SI B13 14 10
Fuel Systems

July 2013
Technical Service

This Service Information bulletin supersedes SI B13 14 10 **dated April 2011.**

Voluntary Emissions Recall Campaign 10E-A02: N54 Inspection and Replacement of Injectors

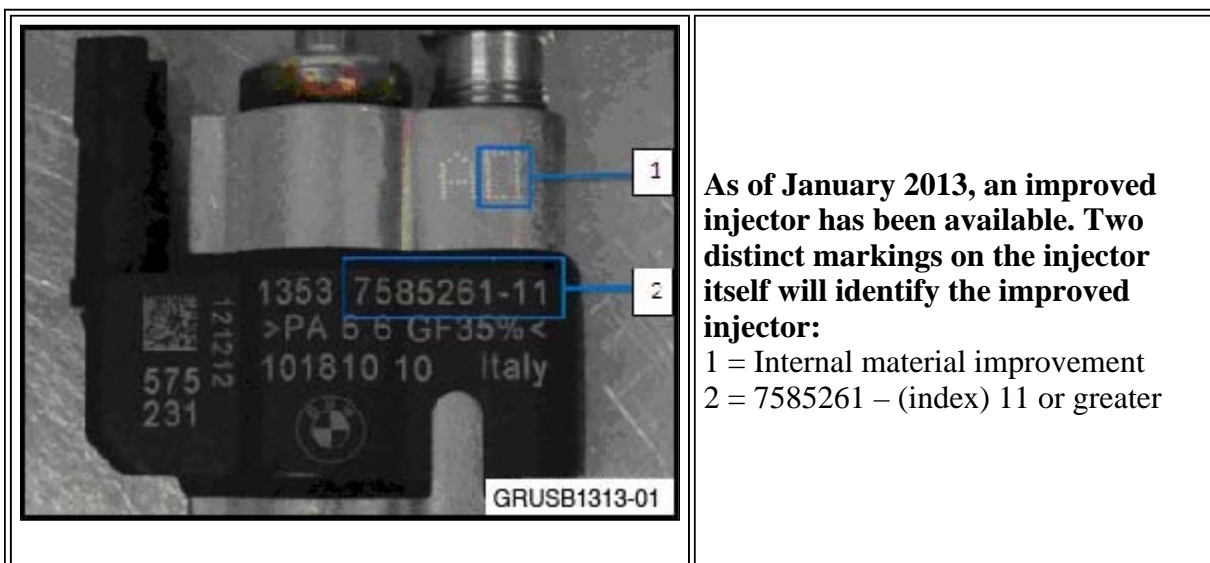
For the injectors already removed, scan the rectangular bar code located in the upper left part of the plastic housing, next to the injectors' part number (indicated as # 2 in the illustration). The 34 or 36-digit line should appear in the corresponding cylinder's line.

IMPORTANT: Injectors with index 11 and higher have a different calibration and construction than injectors with index 10 and lower. Due to this difference, injectors with index 11 and higher and injectors with index 10 and lower cannot be mixed on the same engine bank (i.e., cylinders 1-3 or 4-6). See the photo below to properly identify the index number.

As of January 2013, an improved injector has been available. Two distinct markings on the injector itself will identify the improved injector:

- 1 = Internal material improvement
- 2 = 7585261 – (index) 11 or greater
